[Docket No. FAA-2023-0668; Project Identifier AD-2023-00199-R; Amendment 39-22453; AD 2023-11-07]

Airworthiness Directives; Various Helicopters

Final rule; request for comments.

Figure 1 to paragraph (g)(1)(i)— *Fundamental Effective Isotropic PSD at Outside Interface of Rotorcraft Antenna*

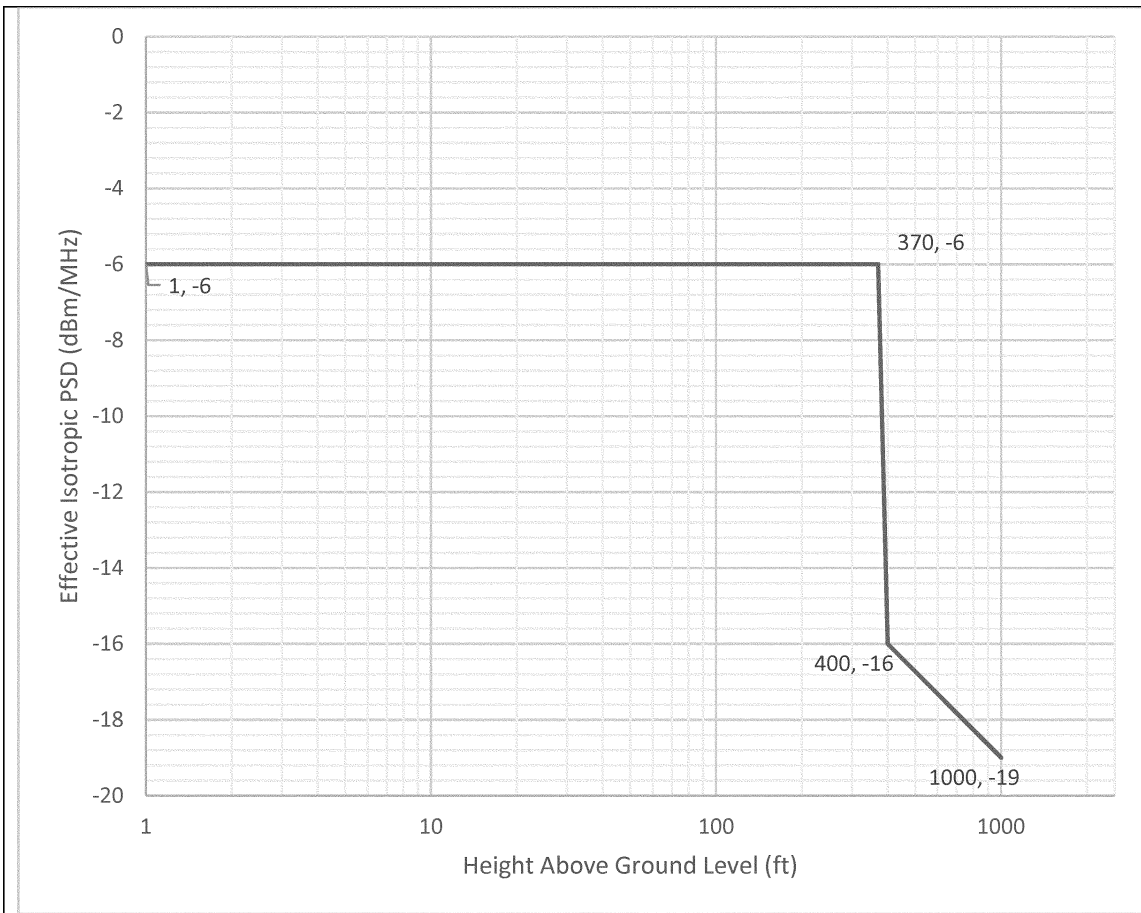
Comment summary: Thales and Sikorsky requested the FAA clarify several aspects of the PSD curve in figure 1 to paragraph (g)(1) of the proposed AD: whether no elevation mask is taken into account at and below 350 feet above ground level (AGL); at which base station emission power the PSD curve corresponds (62 dBm/MHz or 65 dBm/MHz); and whether the radio altimeter performance criteria in the curve explicitly covers any 5G emitter station up to 65dBm/MHz in the applicable 3.7–3.98 GHz band, for the foreseeable future. Sikorsky requested that the FAA revise the proposed AD to include a PSD curve that reflects the reduced EIRP levels for helicopters operating at the 188 priority airports (5G CMAs) with reduced power levels.

Comment summary: Sikorsky requested the FAA revise the PSD curve in figure 1 to paragraph (g) (1) of the proposed AD to change the height above ground at -6 dBm/MHz from 270 feet to 370 feet, and at -16 dBm/MHz from 300 feet to 400 feet. Sikorsky stated its request was based on several factors, including the minimum safe obstacle avoidance distance and the typical decision height used for radio altimeter critical operations associated with missed approach points (MAPs) during point in space (PINS) approaches. Sikorsky further stated that radio altimeters are not operationally used above 1000 feet, and therefore there is little value for any PSD restrictions above 1000 feet operationally.

FAA response: The notch in the PSD curve does not mean that no elevation mask is taken into account below 350 feet AGL. The elevation mask is taken into consideration below 350 feet AGL and is a fundamental consideration in how the PSD curve was established. The PSD curve was calibrated to cover 5G C-Band emitter stations up to 65 dBm/MHz in the applicable 3.7–3.98 GHz band.

FAA response: The FAA assumed an emitter base station height of 350 feet based on consensus reached in rotorcraft industry group meetings. Additionally, FAA analysis of existing emitter base station height data shows that, while higher emitters do exist, they are infrequently adjacent to helipads. Second, the FAA assumed the rotorcraft was no closer than 50 feet above and 75 feet laterally from the emitter. The vertical distance was based on pilot feedback and the lateral distance was based on common lateral separation from the main rotor tip recommendations of 2 main rotor diameters from the tip of the rotor, selecting a 30 foot rotor as the smallest rotor in this class of aircraft with the antenna under the main rotor mast. An operator of an individual model rotorcraft with a larger rotor diameter may request approval of an AMOC to the AD on the basis of separation distance. Third, the FAA assumed that the emitter was active at the full rural power level of 65 dBm/MHz allowed in FCC Report and Order FCC 20–22.[\[2\]](#) The FAA then evaluated the resulting curve against data from radio altimeters and found it to be achievable with current technology using filters that have been developed. Based on data from existing emitters, if the height reduction from 370 feet to 270 feet, as requested by the commenter, were adopted, it would result in many more landing scenarios unprotected from interference because emitters on towers at about 250 feet as opposed to the accepted assumption of 350 feet are much more common. For this reason, the FAA did not adopt this request.

The FAA has re-evaluated the need for PSD performance requirements above 1000 feet and agrees with the reasons provided by the commenter. The PSD curves specified in this AD have been changed accordingly.

Figure 2 to paragraph (g)(1)(ii): *Spurious Effective Isotropic PSD at Outside Interface of Rotorcraft Antenna*

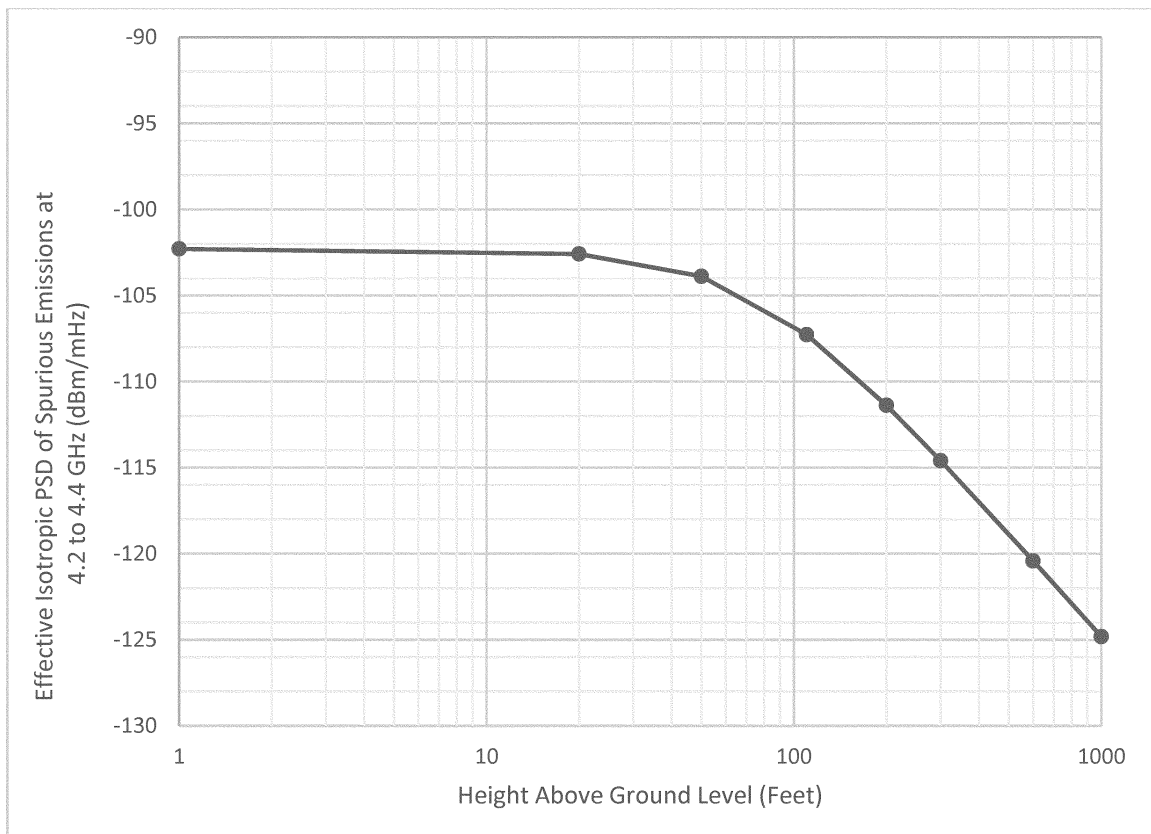
Comment summary: HAI, Sikorsky, and Thales requested that the FAA revise the proposed AD to include the frequency range to which the PSD tolerance curve thresholds apply, a new figure indicating the spurious tolerance similar to the figure with the PSD tolerance curve, and a specification of the altitude dependence for spurious tolerance.

In this final rule, the FAA replaced the proposed fixed aggregate spurious emission level of -42 dBm/MHz (conducted) with a spurious PSD tolerance curve for 5G C-Band interference from a single base station. This form of the requirement is consistent with the transport and commuter category airplane requirement. Similarly, it does not include an aggregation factor or any base station or aircraft antenna gain factors. The spurious PSD tolerance curve is based on a different spurious emission level than what the FAA proposed in the NPRM (-30 dBm/MHz conducted for a single indoor base station instead of -48 dBm/MHz conducted for a single outdoor base station and an aggregation factor of 6 dB which yielded an effective aggregate level of -42 dBm/MHz).

As a result, the FAA is requesting comments on the spurious PSD tolerance curve in figure 2 to paragraph (g)(1)(ii) of this AD.

FAA response: The FAA agrees and has added the frequency range to the PSD tolerance curve. Additionally, as explained previously under “Actions Since the NPRM Was Issued,” the FAA has replaced the proposed fixed emission level with a spurious PSD tolerance curve.
